## Product Change Notification / JAON-01KOJO966

CCB 4912 Final Notice: Qualification of a new lead frame with 68x94 mils lead frame paddle size for selected MCP1653, MCP73833, MCP73834, MCP73837, and MCP73838 device families available in 10L MSOP (3x3mm) package assembled at NSEB assembly site.

**CCB 4912**  
**Pre and Post Change Summary**  
**PCN#: JAON-01KOJO966**

## Pre change NSEB

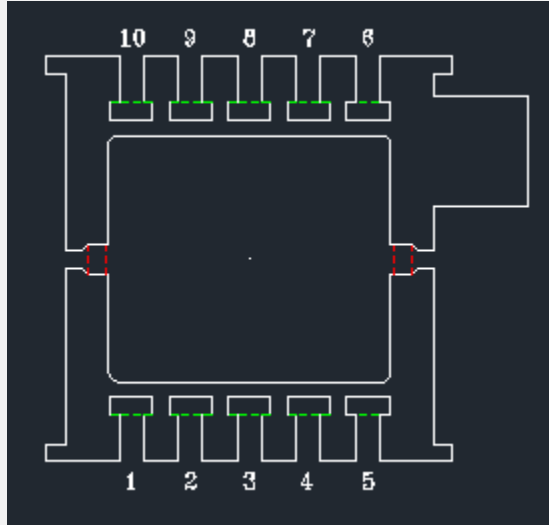
<b>Lead frame material</b>	C7025
<b>Lead frame Paddle Size</b>	82x94 mils
<b>Lead frame Lead Lock</b>	No

## Post Change NSEB

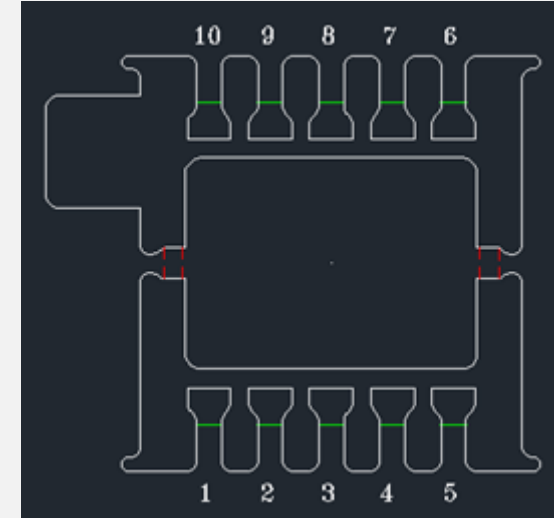
<b>Lead frame material</b>	C7025
<b>Lead frame Paddle Size</b>	68x94 mils
<b>Lead frame Lead Lock</b>	Yes
